STATE OF IDAHO
DEPARTMENT OF WATER RESOURCES
IN-OFFICE REVIEW/BENEFICIAL USE FIELD REPORT

A. GENERAL INFORMATIONPermit No: 75-14088

SUBJECT: Review of System for Licensing

SPRING HEADBOX & COVER DIAGRAM

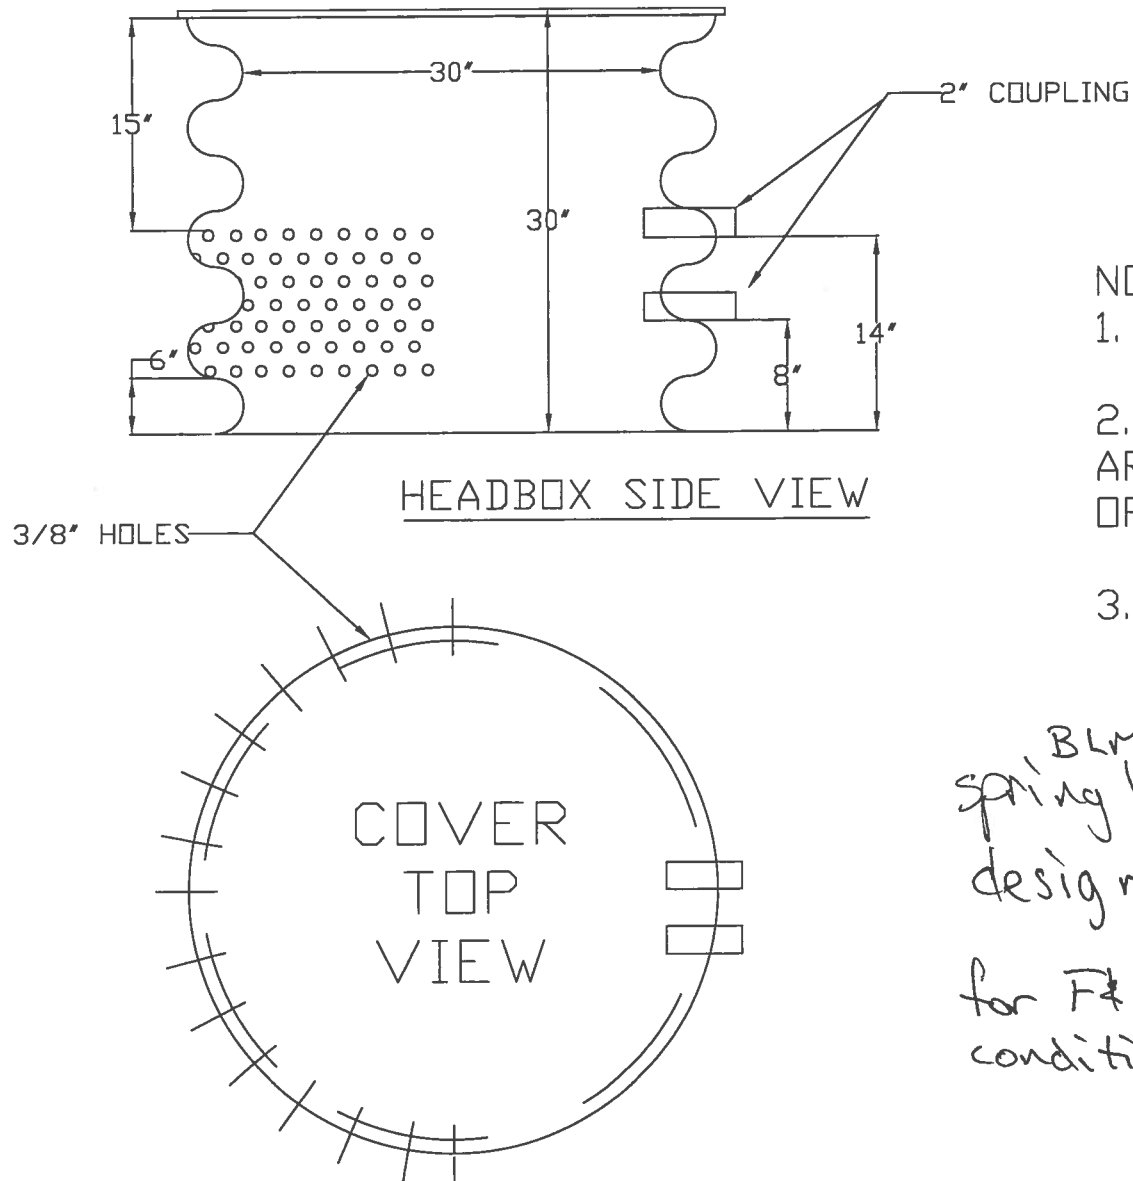
Fish Screen condition – Diagram supplied by BLM indicating 3/8 in screen.

BLM
spring box
design
for F&G
condition
